MMO Reference: DCO/2019/00005
Planning Inspectorate Reference:
EN010117
Identification Number: 20045232

Planning Act 2008, E.On Climate and Renewables UK Ltd, Proposed Rampion 2 Offshore Wind Farm Order

Deadline 1 Submission – Summary of MMO Relevant Representation

Deadline 1 Submission

Annex 1 Indicative construction programme for Rampion 2 (from document reviewed in point 6)

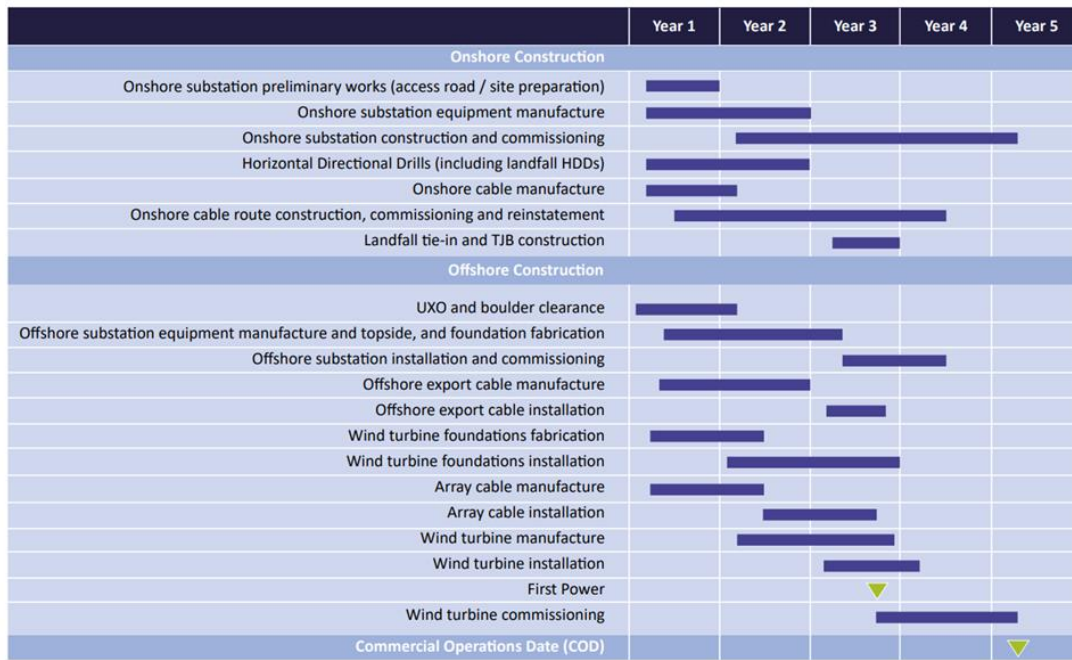
2.1.5 The map in Annex 1 (Figure 5.4.1 from our RR) provides a UK-scale map of projects on the Applicant's 'short-list'. This figure has a smaller map inset which depicts the developments surrounding Rampion 2 at a more appropriate geographic scale. However, there is no discussion on this inset map, which provides a truer short-list of developments with potential for cumulative interactions, within the document. The Applicant should present the developments highlighted in the inset map of Figure 5.4.1 under a separate table as a more meaningful 'short-list' of developments relevant for inclusion in
